ANACORTES PLANNING COMMISSION

- 1) Public Hearing: CUP-2022-0001 - Fiddlehead School Expansion

Planning Commission Public Hearing Minutes for March 9, 2022

Proposed Site Plan
 807 27th Street
 February 4, 2022

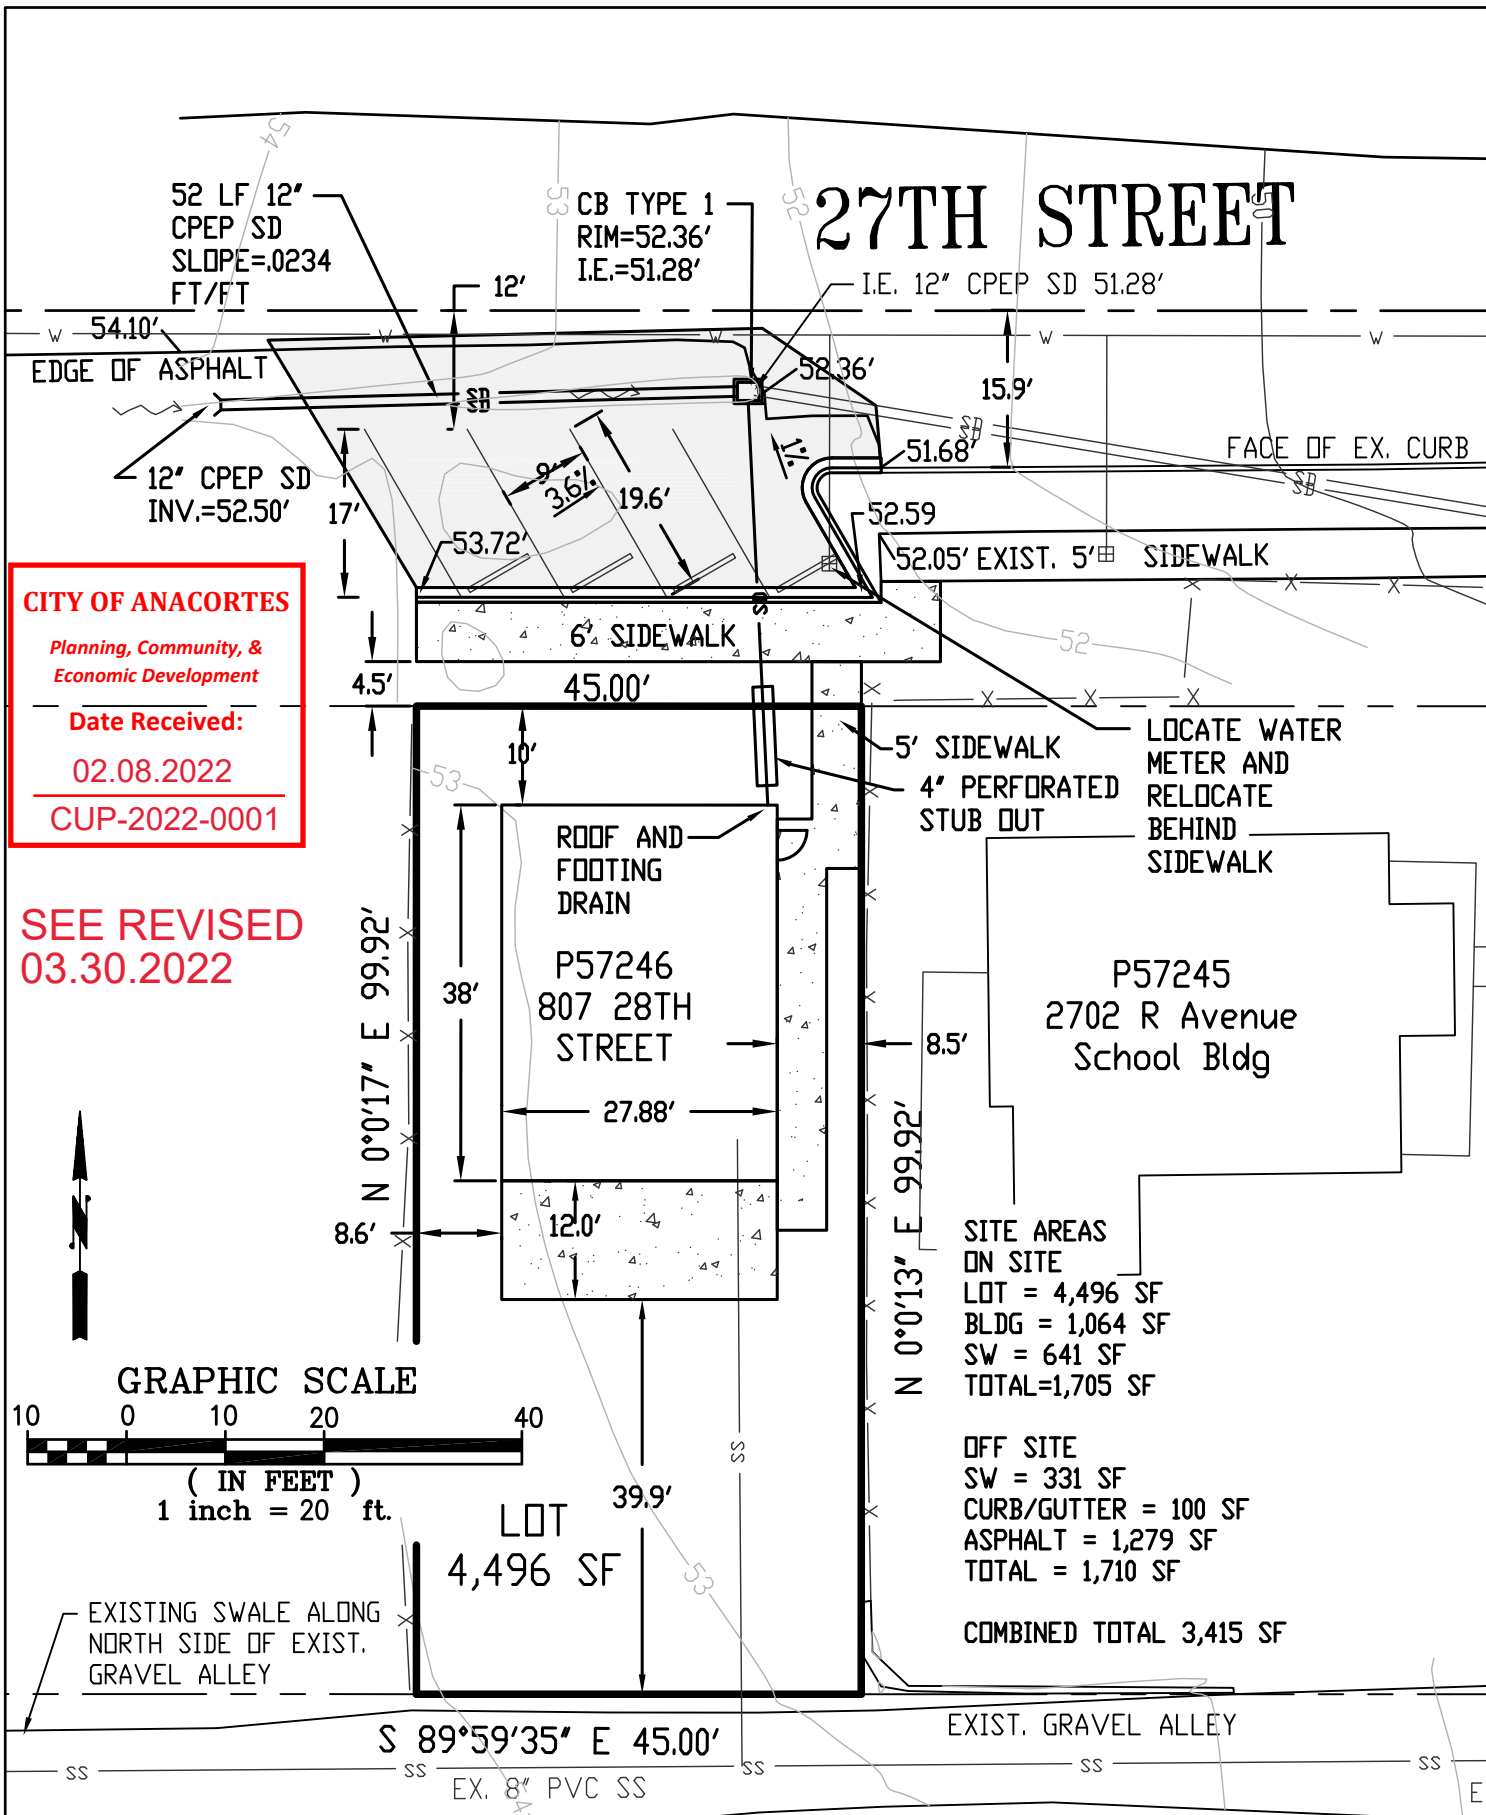
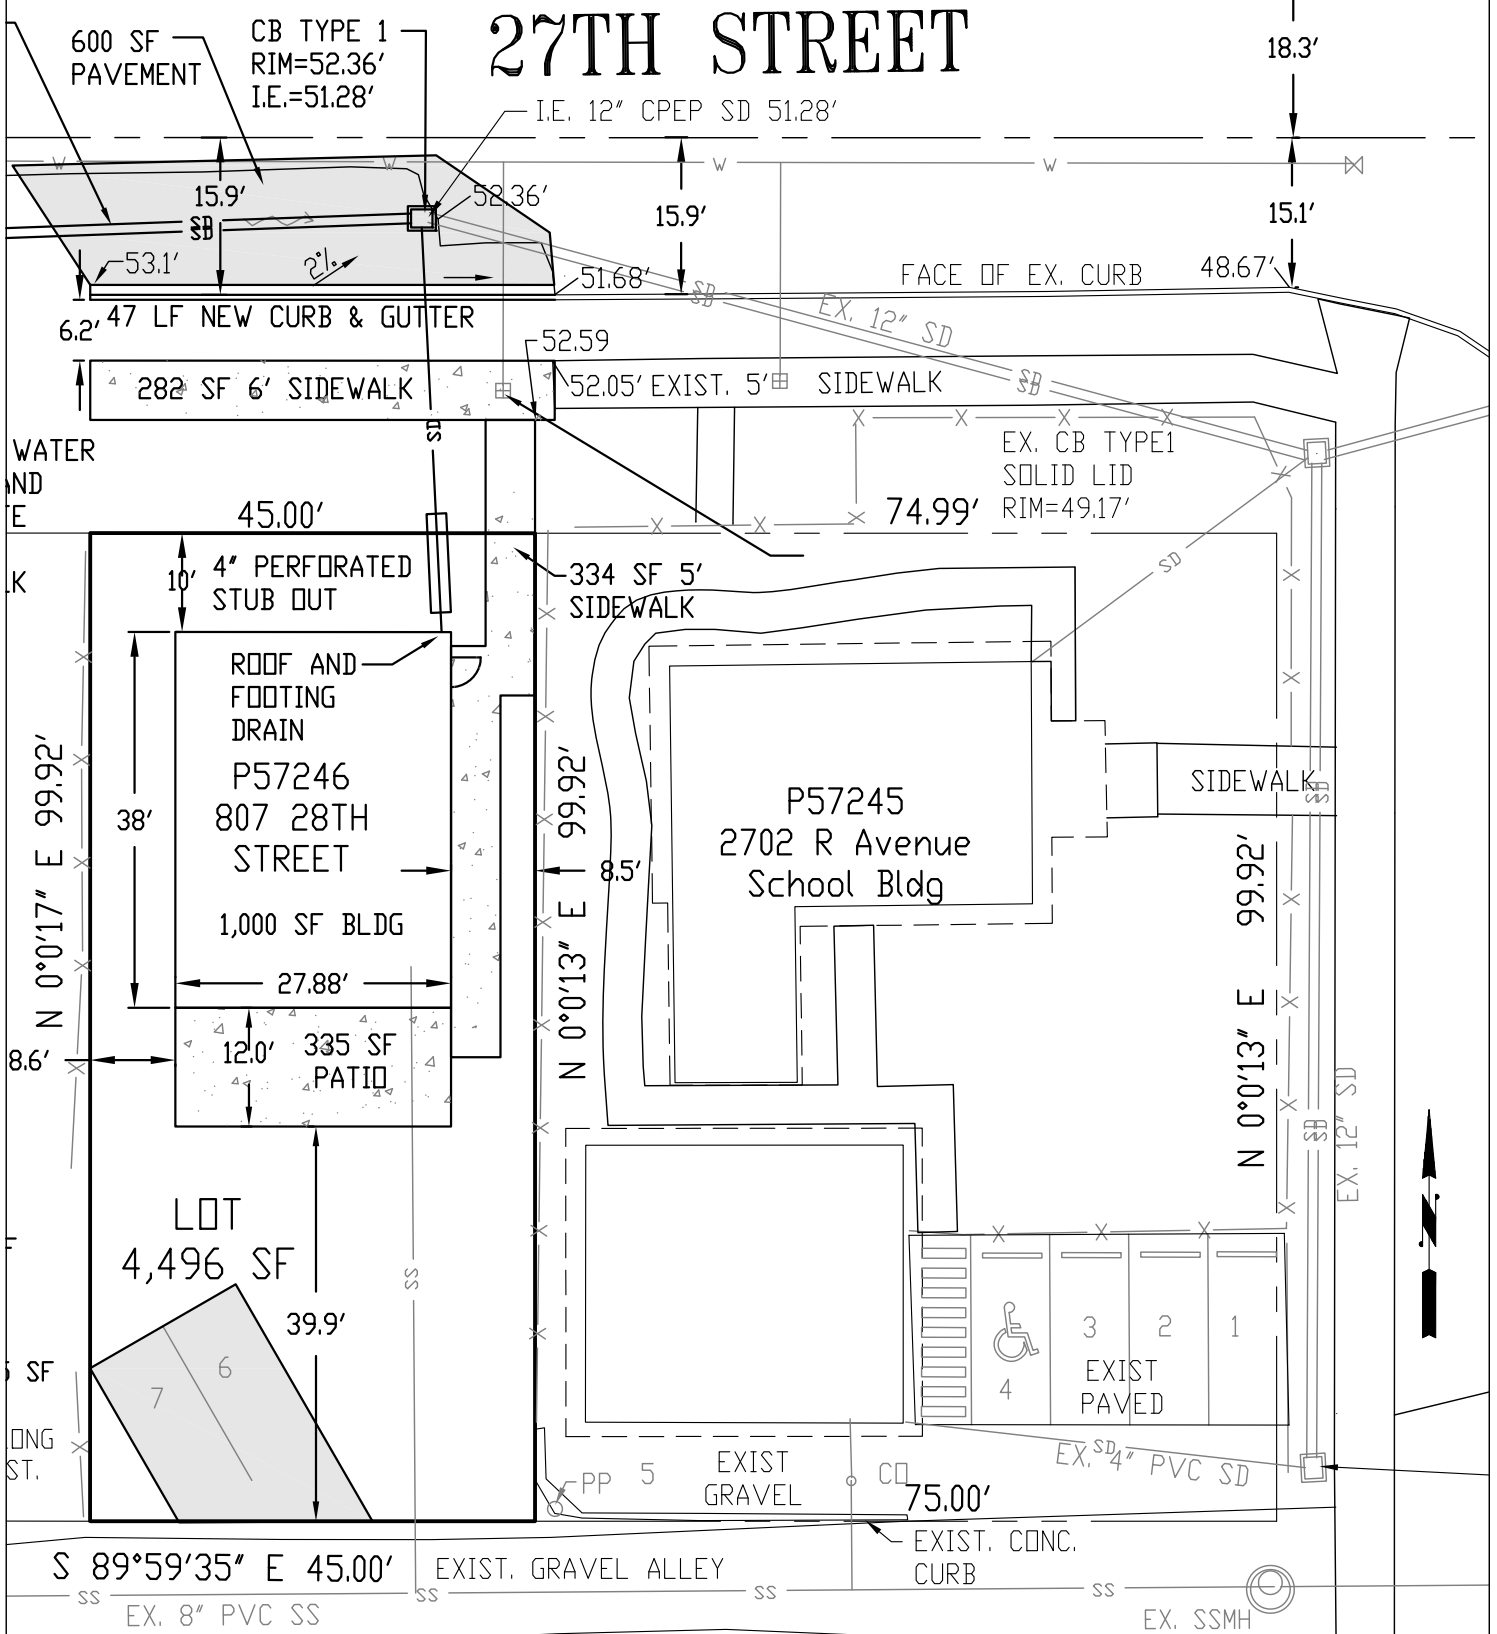
- 1) Please revise/provide a site plan that includes the existing school facilities. Additionally, please include the required landscaping/fencing for the proposed expansion.
- 2) Please provide the current number of students and the number of students anticipated with the expansion.

Please see the revised site plan including the other parcel & building and the landscape/fence plan. Also, Kelly let me know the following for students:

Job 807 27TH ST - FIDDLE HEAD EXPANSION
Title CITY CALL'S FOR IMPERVIOUS SURFACE
Calculated by STEVEN LANGE DATE 03.16.2022
Checked by _____ DATE _____
Sheet 1 of 1 SCALE N.T.S.

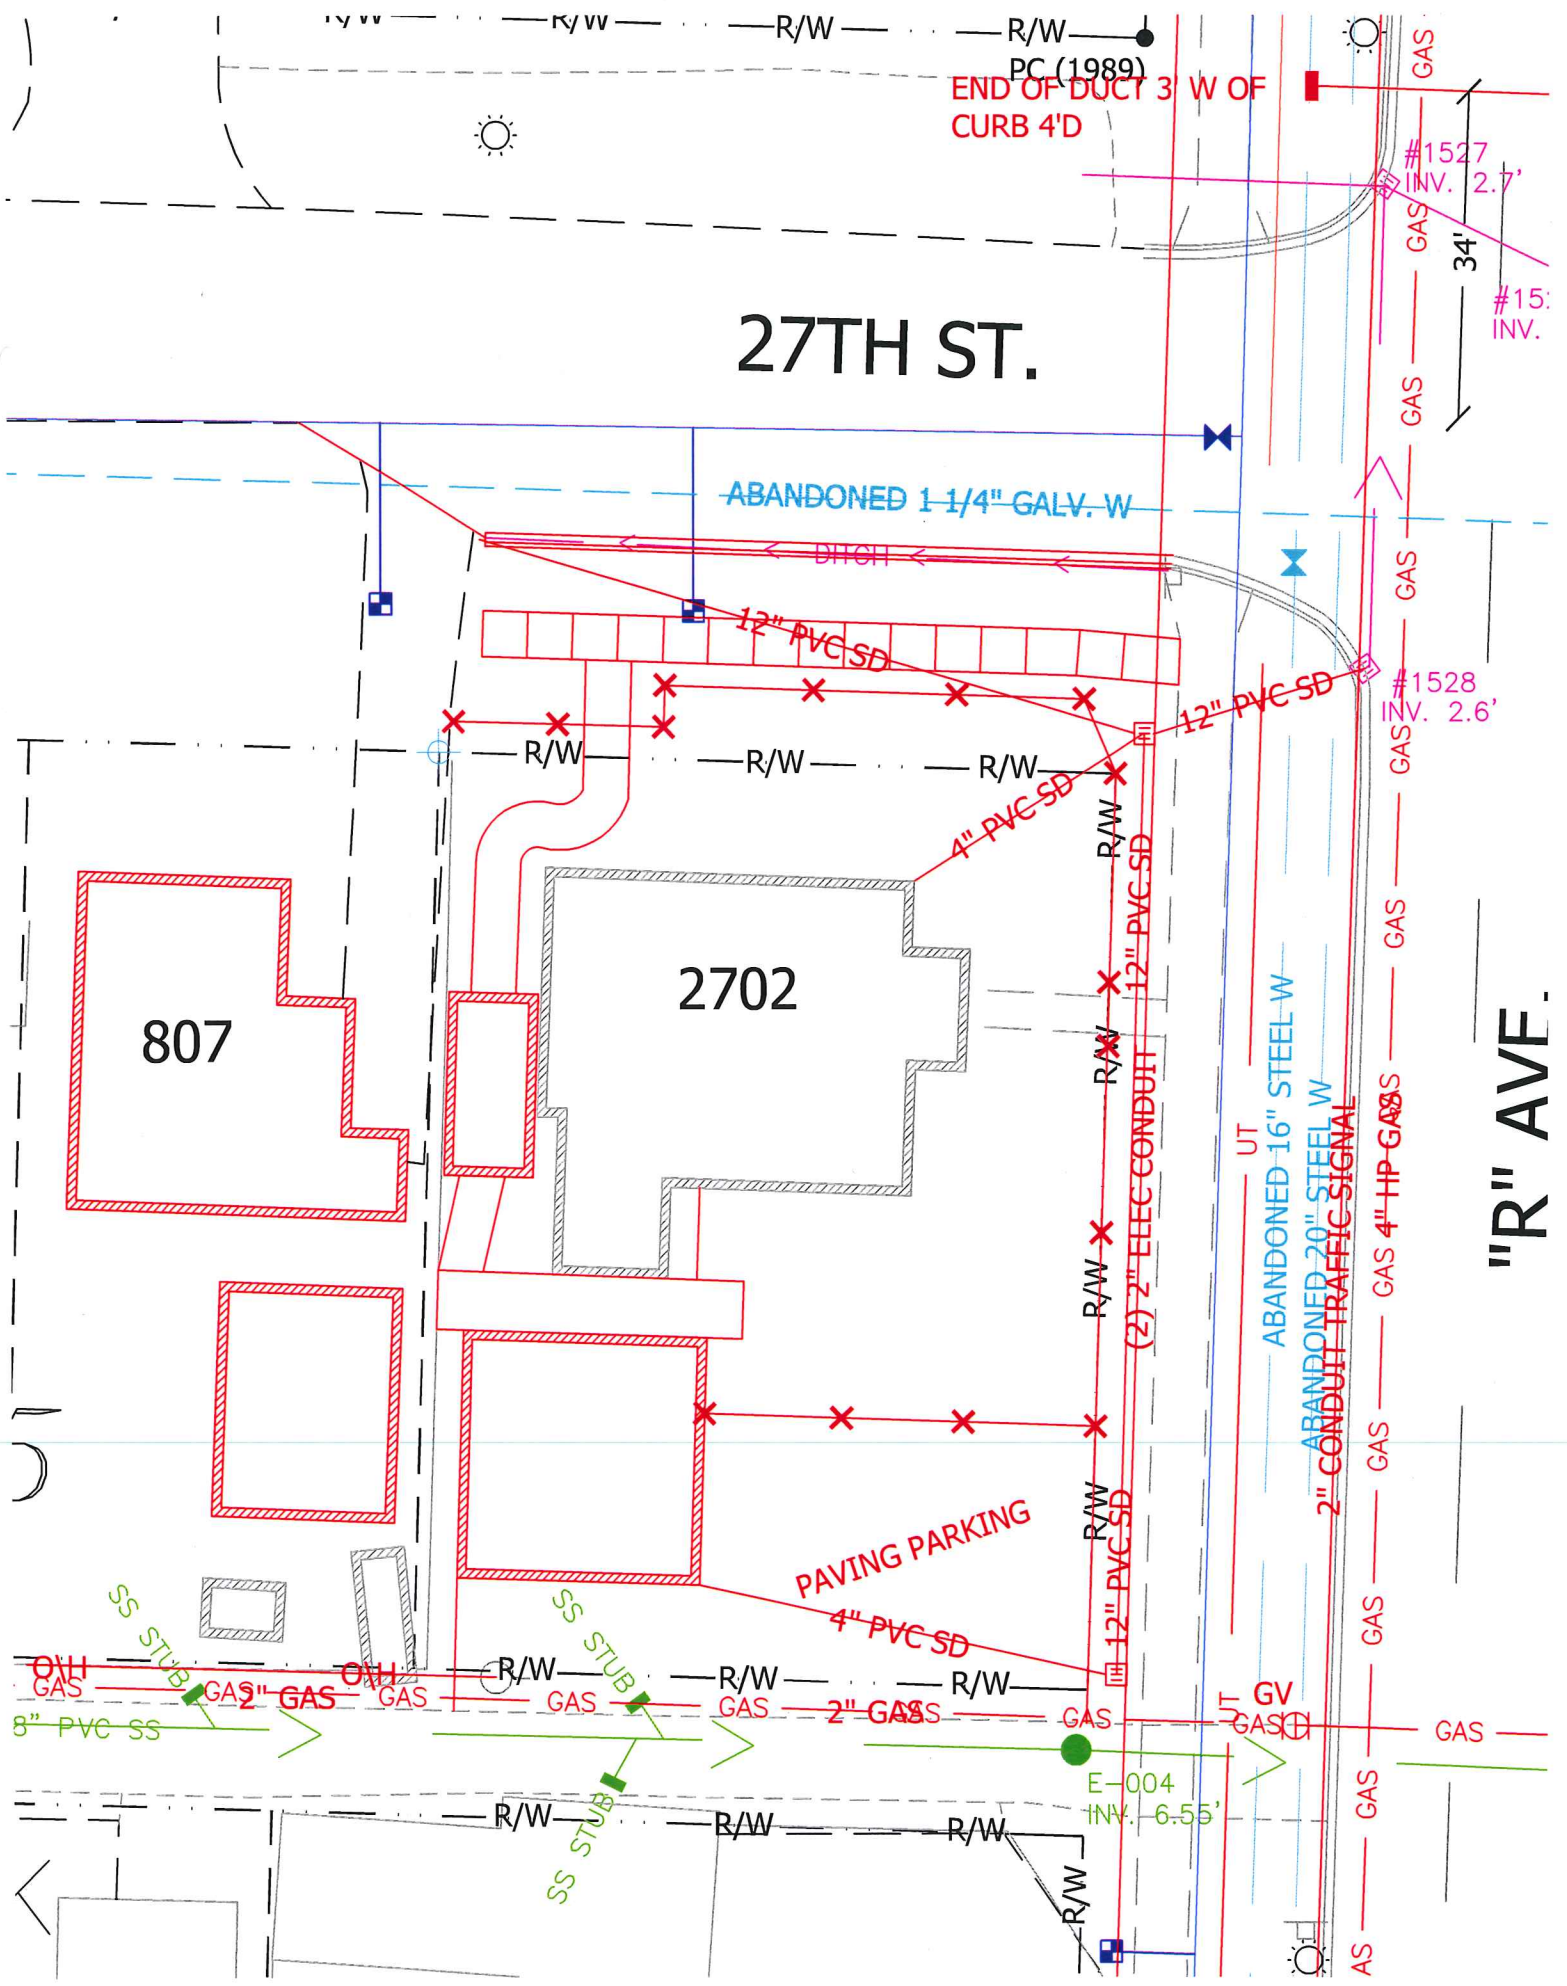
The Public Works Engineering Department completed a review of the submitted drainage report for the above referenced project on February 24, 2022. Below are the comments:

This project is part of a larger Common Plan of Development, that includes the existing facility to the east. The project to the east did not have a drainage report at the time there was a change of use of the property.

Please submit a drainage report that includes 2702 R Avenue.
